Grid Code Modification Recommendation Form

Title of Recommended Proposal: Clarification Modification on WFPS Voltage Control

MPID 270

Date:	05/04/2017	
Recommended at GCRP Meeting No.:	#1/2017 (31 January 2017)	
Grid Code Section(s) Impacted by		
Recommended Proposal:	Deleted Clauses	Modified Clauses
	WFPS1.6.2.5	WFPS1.6.3.1
	Figure WFPS1.3	Definition of
		Generator
		Transformer
	WFPS1.6.5.1	Definition of Grid
		Connected
		Transformer
Grid Code Version:	6.0

Figure WFPS1.3 - Locations for **Voltage Regulation** set point (Z) and the **Power Factor** range (Y). The HV side of the **WTG** transformer is (X)

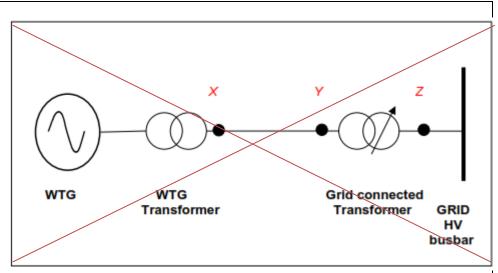
A modification specifying new Reactive Power requirements for WFPS, <u>MPID228</u>, was approved by the CER, 26 February 2013. At that time, Figure WFPS1.3 was not updated to align with the revised text in section WFPS1.6.3.1.

At the GCRP meeting, 11 Oct 2016, a housekeeping modification was proposed to amend Figure WFPS1.3 to align it with the clause WFPS1.6.3.1. At this meeting it was noted that Figure WFPS1.3 can cause confusion in certain instances where the connection point is remote from the substation, i.e. where the connection point is not at the high voltage terminals of the grid connected transformer. It was proposed to put the housekeeping proposal on hold pending further examination by the TSO.

Following further examination the TSO proposed a clarification modification that removed Figure WFPS1.3 and any references to the diagram from the Grid Code. This removes uncertainty but will not remove the requirement for WFPS to be compliant at the connection point as per WFPS1.6.3.1.

At the meeting the TSO proposed amending Figure WFPS1.3 to align it with the clause WFPS1.6.3.1. Tony Hearne (DSO) recommended that Figure WFPS1.3 be removed from the Grid Code and the TSO undertook an action to review his recommendation.

- Removing Figure WFPS1.3 instead of implementing the previously proposed change to it
- Adding new text to WFPS1.6.3.1 and removing references to Figure WFPS1.3 in the surrounding text.
- Removing WFPS1.6.5.1 and instead updating the definitions of Generator Transformer and Grid Connected Transformer.

At the GCRP meeting that took place 11 October 2016, the TSO proposed to revise Figure WFPS1.3 to align it with the clause WFPS1.6.3.1. At this meeting Tony Hearne (DSO) proposed that Figure WFPS1.3 be removed from the Grid Code because the diagram doesn't cater for sites where the connection point is remote from the site. The TSO agreed to carry out a review. Following such a review a revised modification proposal was presented to the GCRP members on 31 January 2017. The TSO agreed with Tony Hearne's recommendation to remove the figure and further proposed to revise relevant Grid Code clauses to align with the removal of Figure WFPS1.3.

WFPS1.6.2.5 Figure WFPS1.3 shows the relevant points appropriate to the Voltage Regulation System for a Controllable WFPS. X is the HV side of the WTG transformer, Y is the lower voltage side of the Grid Connected Transformer and Z is the Connection Point.

WFPS1.6.3.1 Controllable WFPSs operating in Power Factor control mode,
Voltage Control mode or constant Reactive Power mode shall be
at least capable of operating at any point within the P-Q capability
ranges illustrated in Figure WFPS1.4, as measured at the
Connection Point over the normal and disturbed Transmission
System Voltage ranges specified in CC.8.3.2; subject to the
exception in WFPS 1.6.3.2, where additional Reactive Power
compensation may be utilised to compensate for the Reactive

The **Grid Connected Transformer** tap changing range must be capable of ensuring nominal voltage at the lower voltage side of the grid connected transformer, for any **Voltage** at the **Connection Point** within the ranges specified in WFPS1.6.1.
